ADDENDUM NO. 2

For: Humble Independent School District
AMS / HMS Additions & Renovations
10203 Birchridge Drive
Humble, TX 77338

PREPARED BY: PFLUGER ARCHITECTS

PROJECT NO: 24-042

1 1E02.12 **COMPOSITE POWER PLAN - HMS**
3/64" = 1'-0"

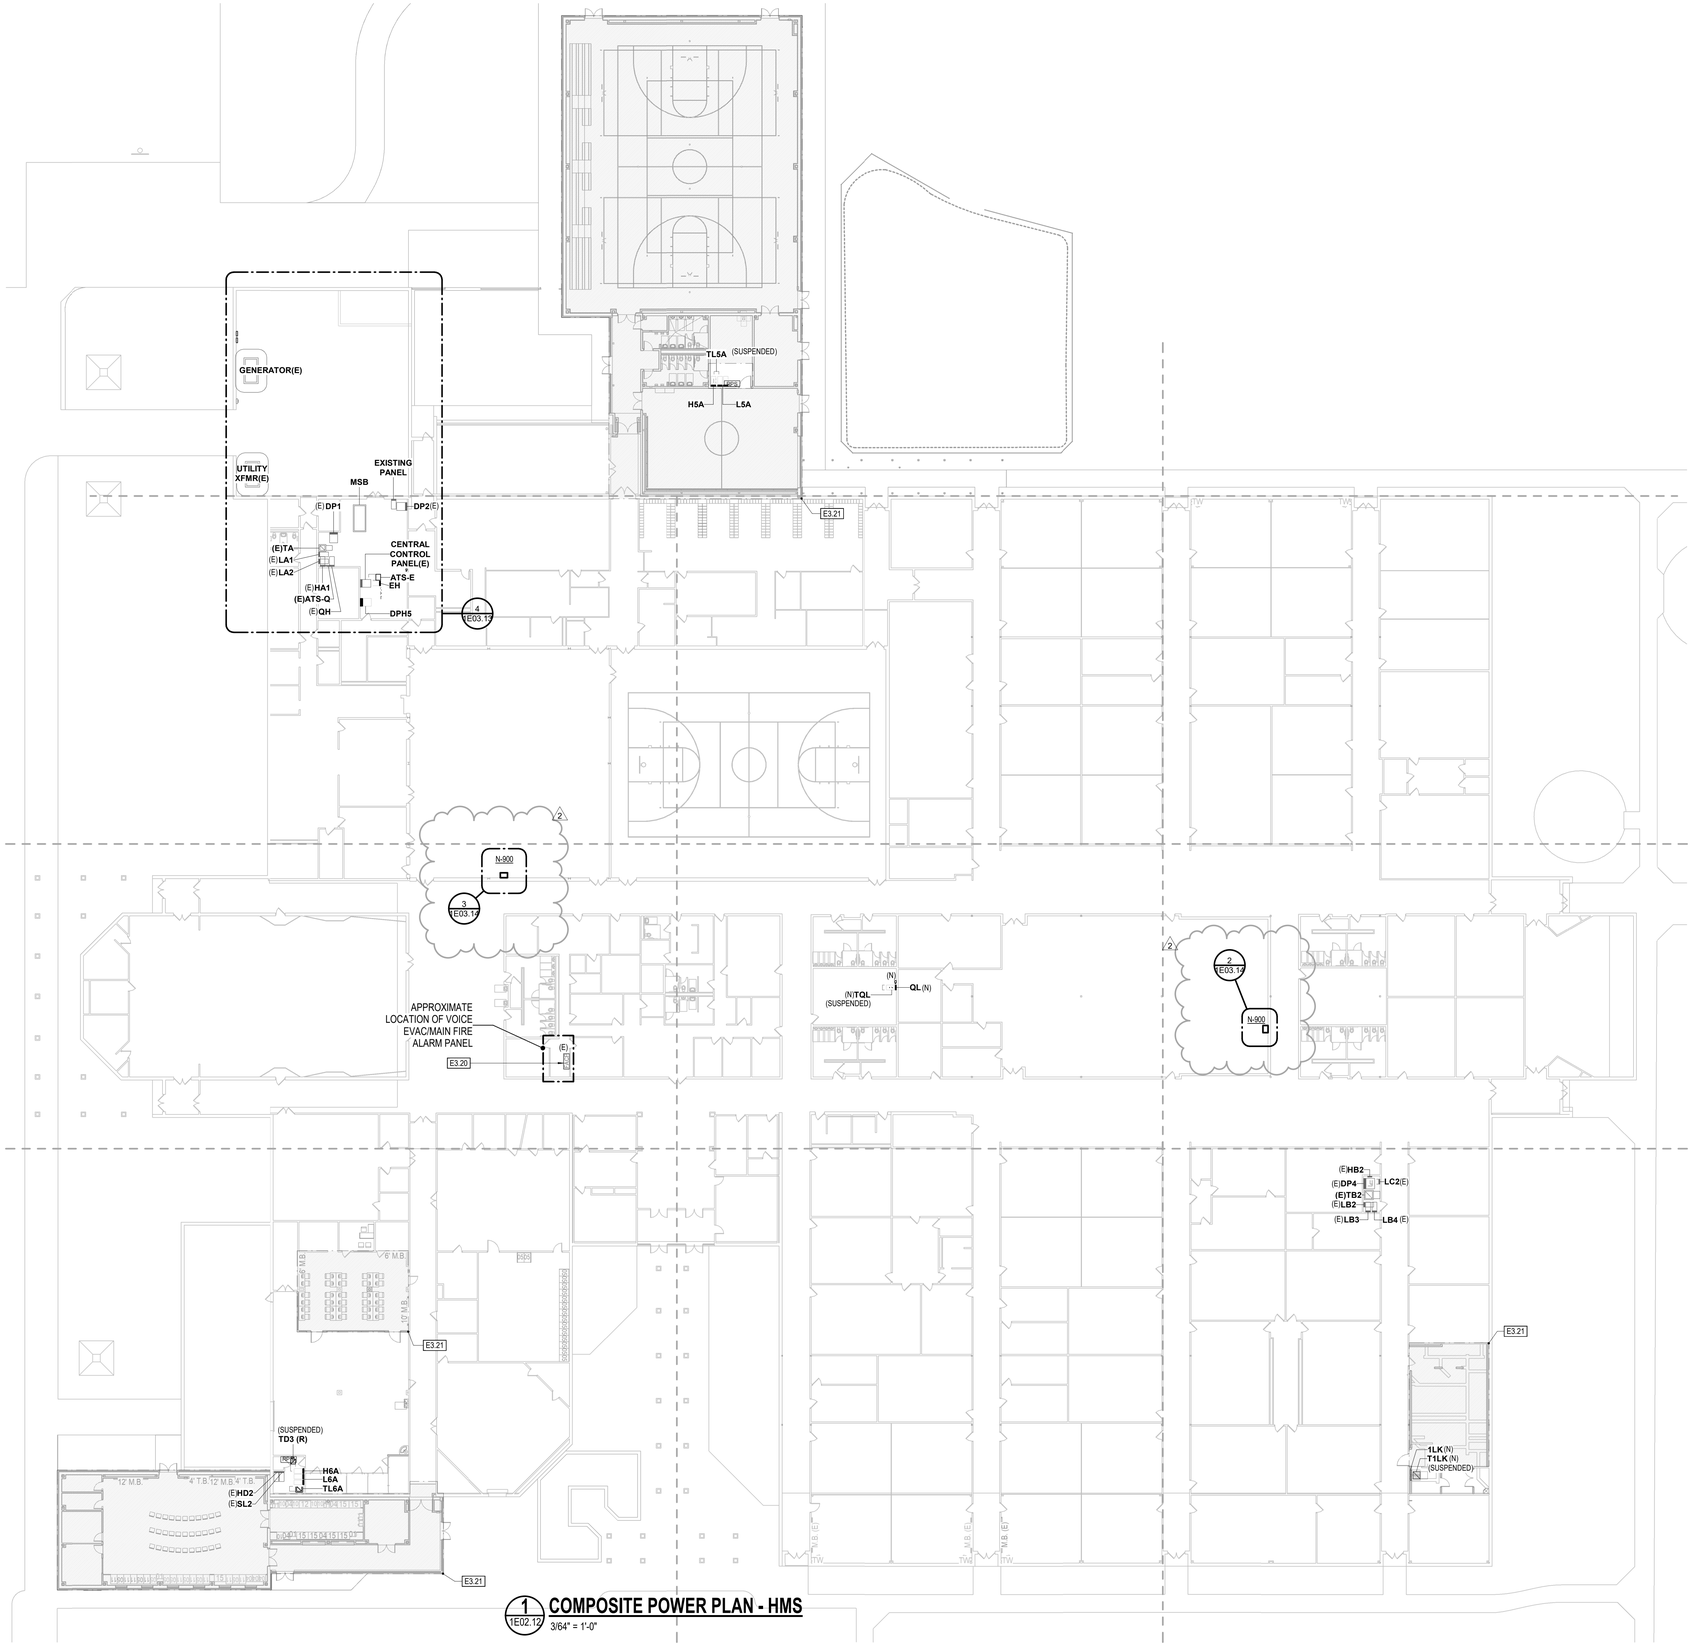
D2-9	1E02.02B	Updated lighting fixture types in culinary lab. See updated sheet.
D2-10	1E02.02G	Added wall pack fixture circuits and updated fixture types. See updated sheet.
D2-11	1E02.12	Added call-outs. See updaeted sheet.
D2-12	1E02.12G	Added (1) new dedicated 120V circuit. See updaetd sheet.
D2-13	1E03.14	Added sheet in its entirety.
D2-14	1E04.01	Updated ATS size. See updated sheet.
D2-15	1E05.01	Updated all eletrical panel schedules. See updated sheet.
D2-16	E4.01	Updated transformer schedule. See updated sheet.
D2-17	E5.01	Updated lighting fixture schedule. Updated Contactors shcedules. See updated sheet.
D2-18	E6.02	Added sheet in its entirety.
D2-19	1P03.01	Added existing cold lines with sizes. Added keynote to cold and hot water line.
D2-20	1T02.02G	Relocated A/V inputs for mobile rack.
D2-21	T6.01	Removed Details 1 and 2 - replaced with new Detail 1 for access control.
ATASCOCITA MIDDLE SCHOOL
